PUBLIC INTEREST REVIEW FOR GROUNDWATER APPLICATIONS

SUBJECT: Application G- 18311 Supersedes review of _____
Date of Review(s)

Applicant's Name:
Christina Arapolu / John & Sandra Thorne; Easy Valley Farm LLC County: **Jackson**

Stream-depletion Model Results (SW#1)

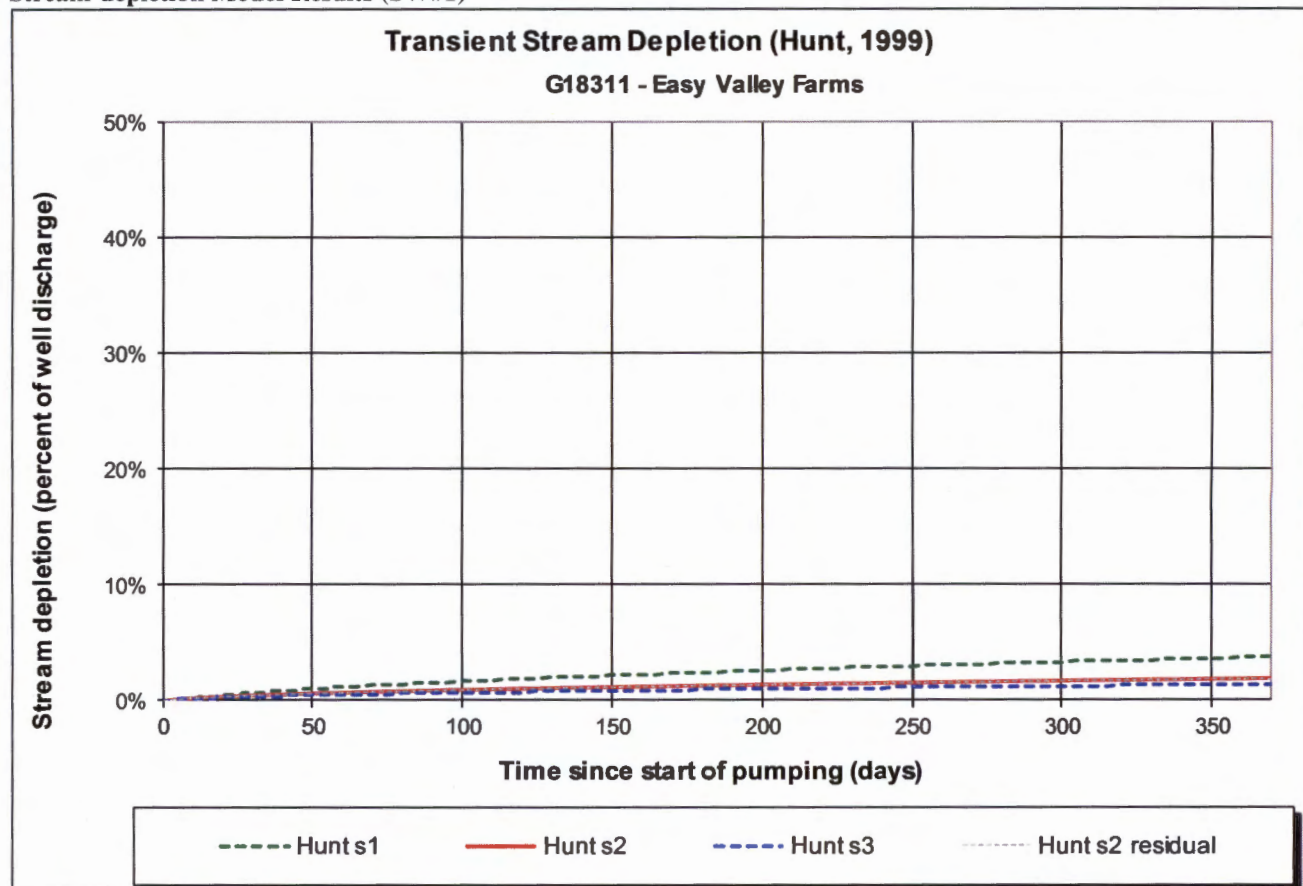
Comments: Interference @ 30d was estimated using the Hunt (1999) analytical stream-depletion model. Model results for SW #1 are attached below.

C6. **SW / GW Remarks and Conditions:** The review found that the applicant's proposed POA would be producing from an unconfined aquifer and is within 1/4 mile of Maple Creek (a mapped, intermittent stream with several permitted surface-water PODs) and within 1 mile of Evans Creek (a perennial stream with two instream water rights and many surface water PODs). The distance to Maple Creek requires the Department to assume that the use will have PSI with Maple Creek but no such assumption is required to Evans Creek. Calculated interference (i.e., stream-depletion) with both streams would be below 1% after 30 days of pumping.
